9/12/14  
OFFICIAL NOTICE NO. 117

### ADDENDUM NO. 1

**CENTURY CITY REDEVELOPMENT**  
**PROJECT AREA "A"**  
SITE CLEARANCE, ENVIRONMENTAL REMEDIATION, AND PRELIMINARY SITE PREPARATION  
2725 WEST HOPKINS STREET, MILWAUKEE, WI

**Department of Public Works Official Notice # 117  
September 11, 2014**

Sheet Number: CD 150

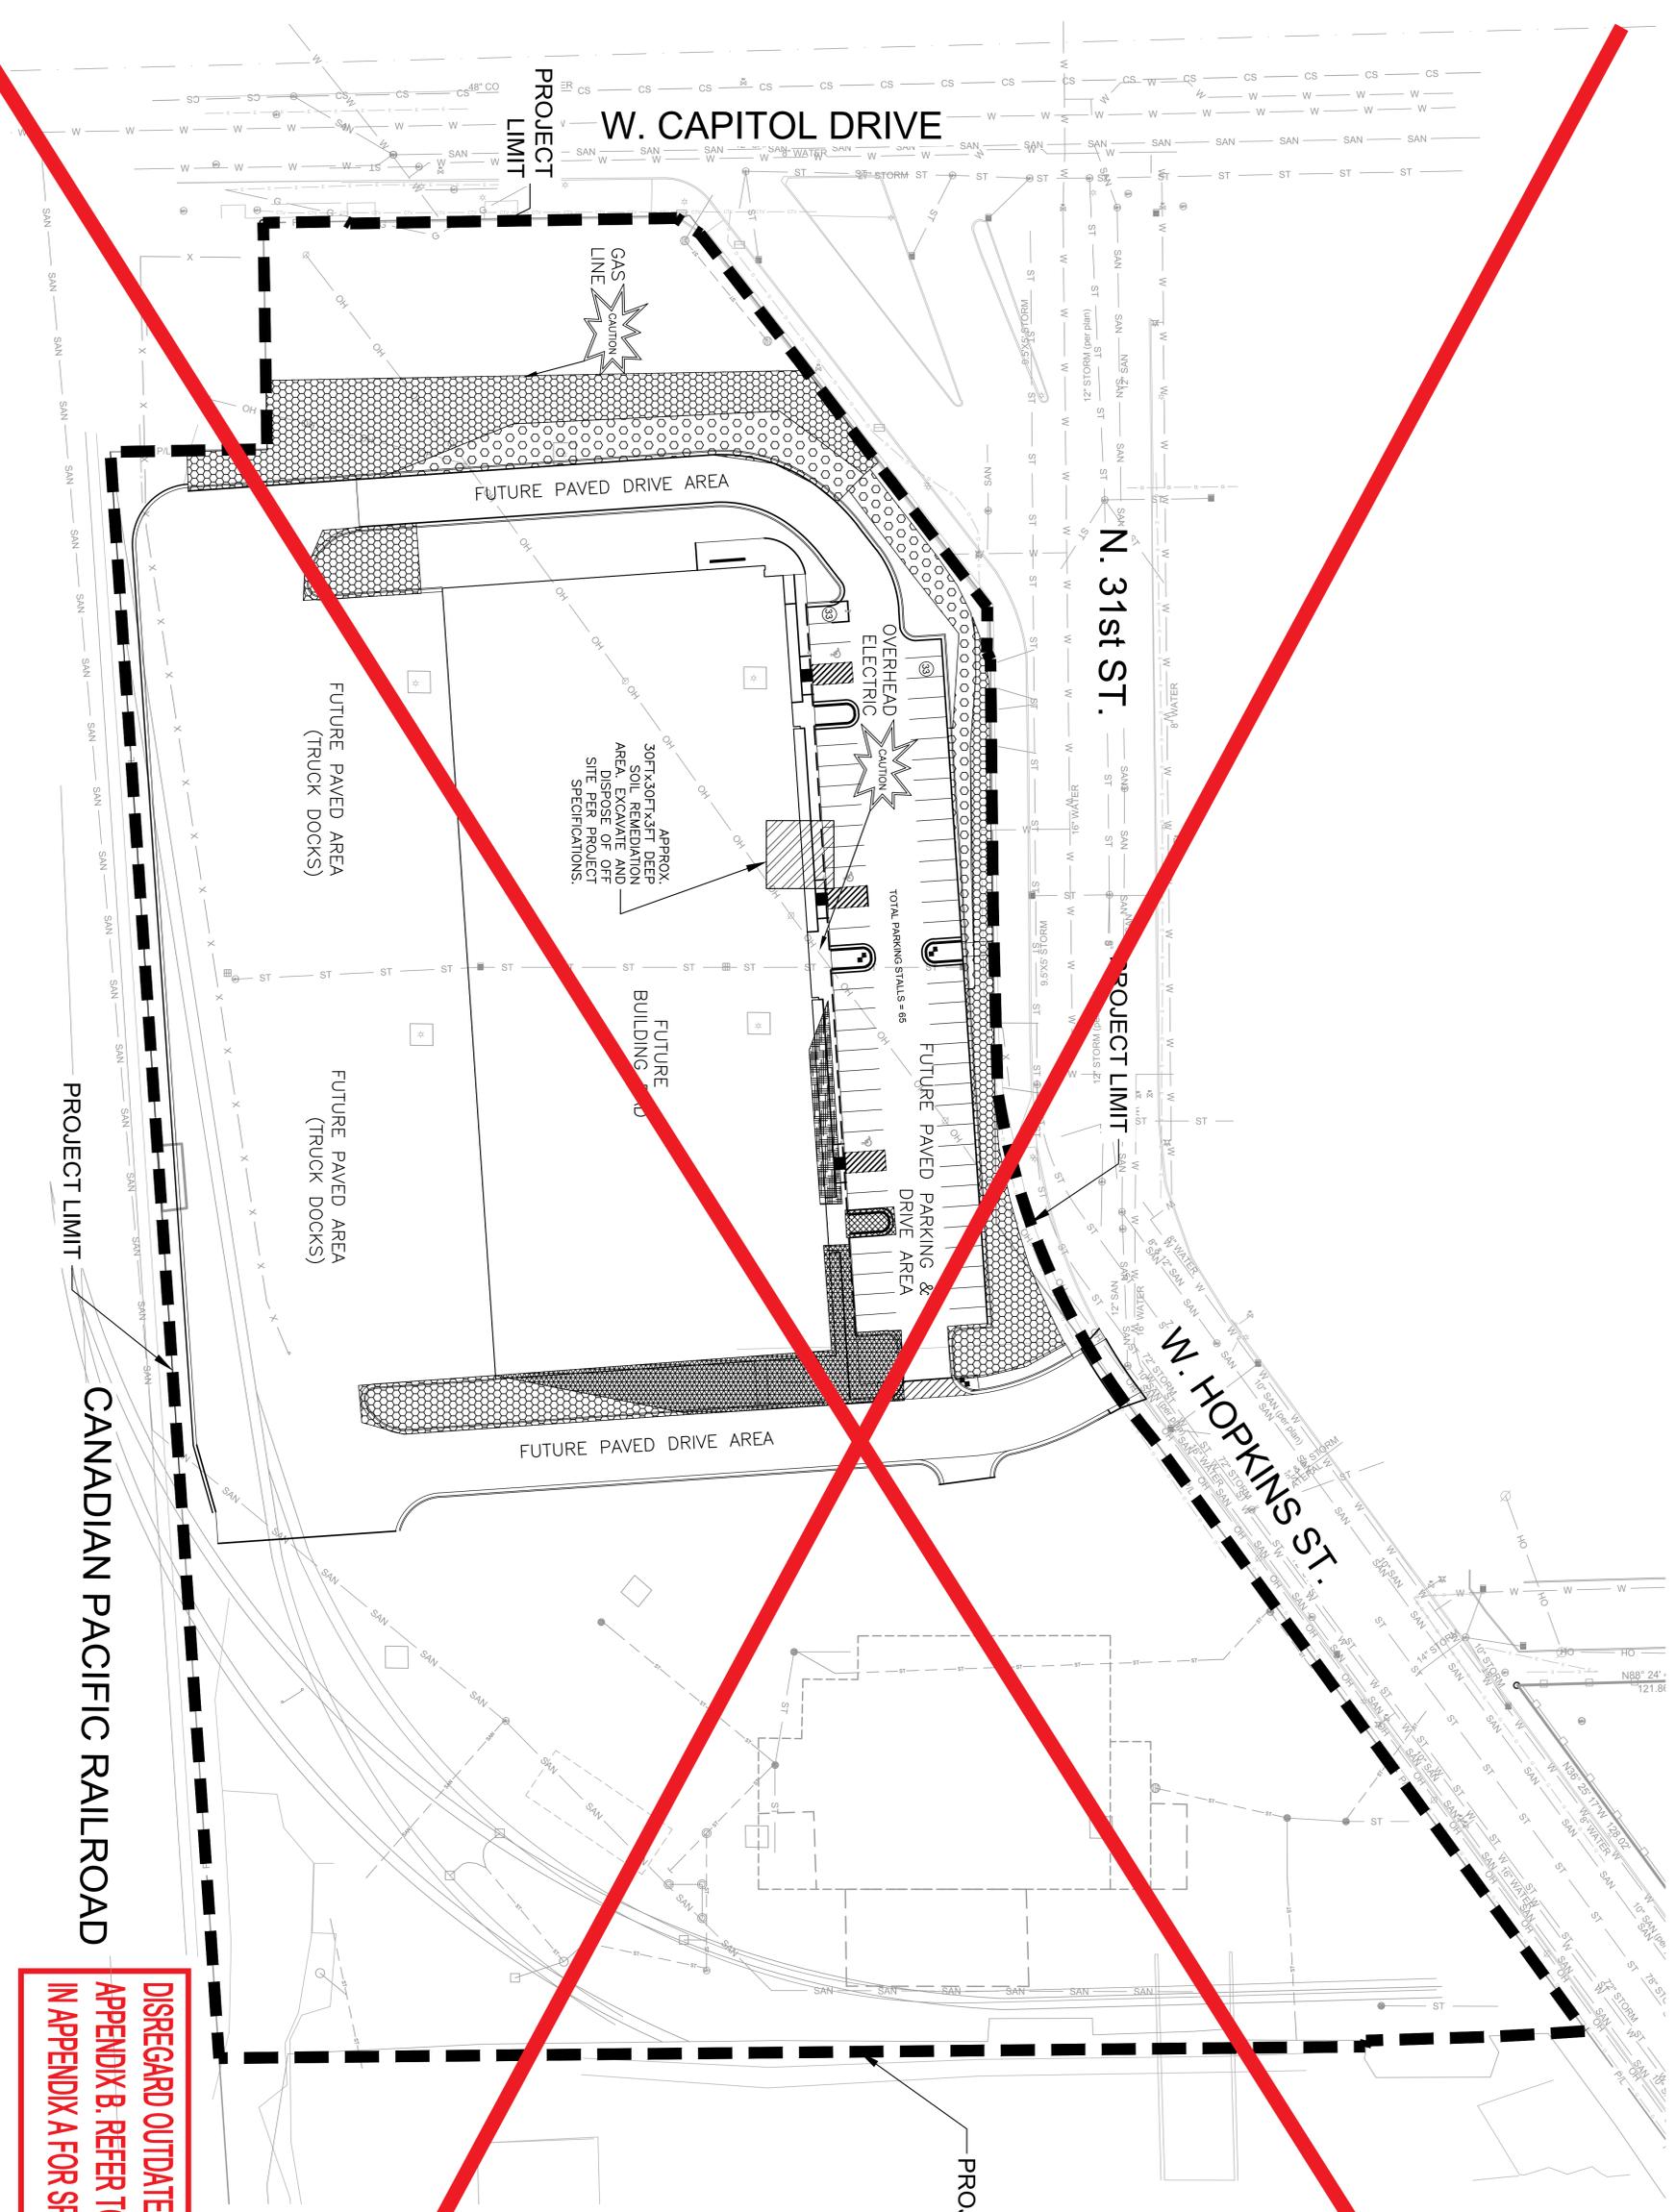
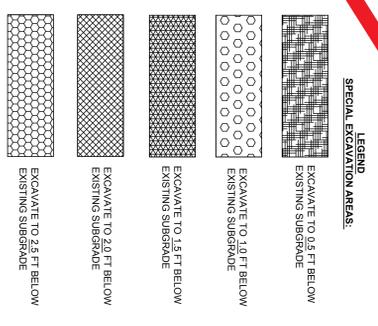
**DISREGARD OUTDATED SHEET CD150 (dated 05/06/14) IN APPENDIX B. REFER TO REVISED SHEET CD150 (dated 08/21/14) IN APPENDIX A FOR SPECIAL EXCAVATION AREA DETAILS.**
